56 Haymoor

1. Matter for Consideration

- 1.1 An application for: Ground Floor Rear Extension, First Floor Side Extension, New Chimney, New Rear Dormer and New Front Rooflight (Retrospective)

RE: 56 Haymoor, New Rear Dormer - Retrospective Permission

Approved Rear Elevation

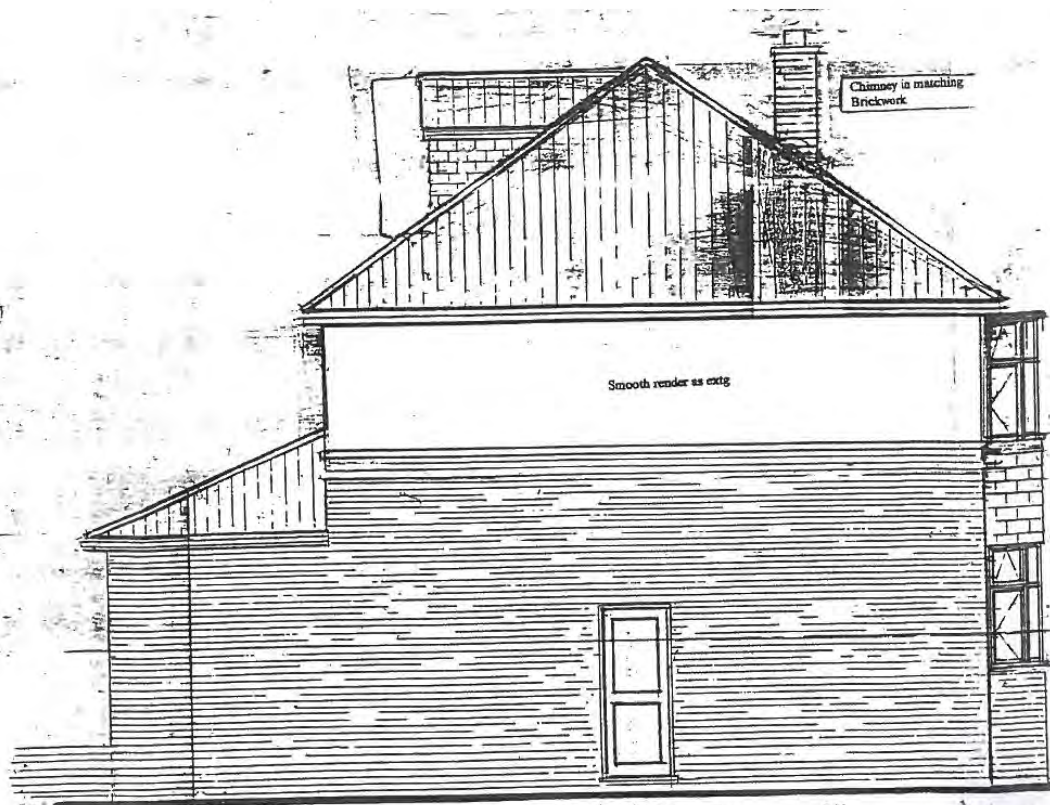
- 3.8 The plans provided by the agent are drawn at slightly different scales, the approximate dimensions are as follows:
 - The approved plan shows the dormer as 1600mm high (to the ridge) and 2550mm deep and 1500mm wide.

- The approved window was 900mm deep and 1100mm wide
 - The built dormer is 2100mm high, 3150mm deep and 1800mm wide.
 - The built window is 1100mm high and 1200mm wide.

- from the drawings submitted, the proposed dormer is 300mm wider than approved. However it is also 500mm higher and 600mm deeper than the proposed dormer.
- the dormer is visible from the roadside due to its scale.
- the dormer is considered to be over dominant to the rear roof plane.
- the dormer is sited approximately 100mm lower than the approved ridge height, however as a flat roof its overall bulk is more dominant than a gable roof and the overall proportions are still excessive.
- the materials are not in question.
- there is also no objection to a dormer in principle, it is the overall mass of the dormer which is considered to be unacceptable.

- i) **REFUSE** retrospective consent for the rear dormer due to its overall bulk and excessive size and the owners be requested to remedy this matter.
- ii) **APPROVE** the other minor alterations.
